IE Bulletin No. 78-05

MALFUNCTIONING OF CIRCUIT BREAKER AUXILIARY CONTACT MECHANISM -  
GENERAL ELECTRIC MODEL CR105X

# 105X AUXILIARY CONTACT (CHANGEOUT OF PLUNGER ARM AND INSULATION)

FIGURE 1  
REMOVING OVERLOAD RELAY MOUNTING BRACKET

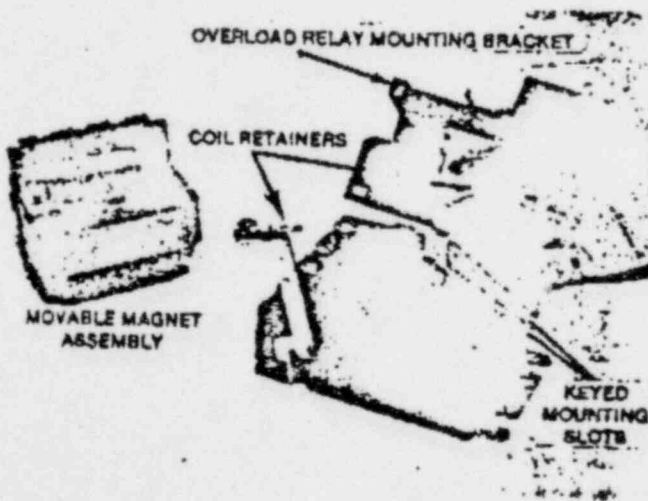
### REMOVING OVERLOAD RELAY BRACKET (SEE FIG. 1)

1. Remove all electrical power from device.
2. Disassemble device by pressing on the coil while pulling out on the coil retainers. Move retainers back and away from coil.
3. Grasp movable portion of magnet and pull out, removing magnet assembly, coil, molded cover and movable arm in one motion. (NOTE: On reversers or multispeed starters, this magnet assembly is linked to the mechanical interlock arm between contactors and should be tipped toward interlock arm to facilitate easy removal.)
4. Remove overload relay bracket by sliding it out of the keyed slots in the molded base. (NOTE: If any wires are too short to allow easy removal, temporarily disconnect these.)
5. Remove overload relay from bracket by loosening screw on bottom of overload bracket.

FIGURE 2

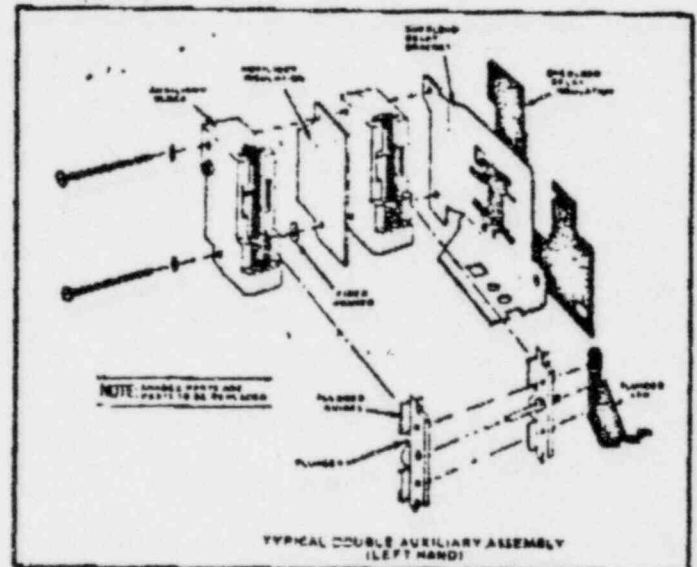
### CHANGING PLUNGER ARM & INSULATION (SEE FIG. 2)

1. Slide plunger assembly out of auxiliary contact block, by lifting up and out.
2. Select the new plunger arm that is bent the same way as the one installed.

3. Loosen screw on plunger to release metal arm but DO NOT REMOVE SCREW FROM PHENOLIC PLUNGER (OR PLUNGERS).
4. Mount new plunger arm on plunger. Fasten arm to plunger with screw (or plunger post if installing double aux. blocks).

5. Apply thin coat of aeroshell grease along plunger guides.
6. Reinstall plunger assembly in contact block.
7. Reassemble overload to mounting bracket. Remove overload insulation and install new. (NOTE: Overload insulation must be removed and replaced with new insulation supplied with kit.)

8. Remount complete assembly on contactor base.
9. Reconnect any wires previously removed.
10. Reassemble magnet assembly to contact base (on reversers or multispeeds be sure to interlock this assembly with mechanical interlock arm. Check for free movement of armature assemblies and mechanical interlocks).

11. Observe that auxiliary contact plunger assemblies are operating properly.
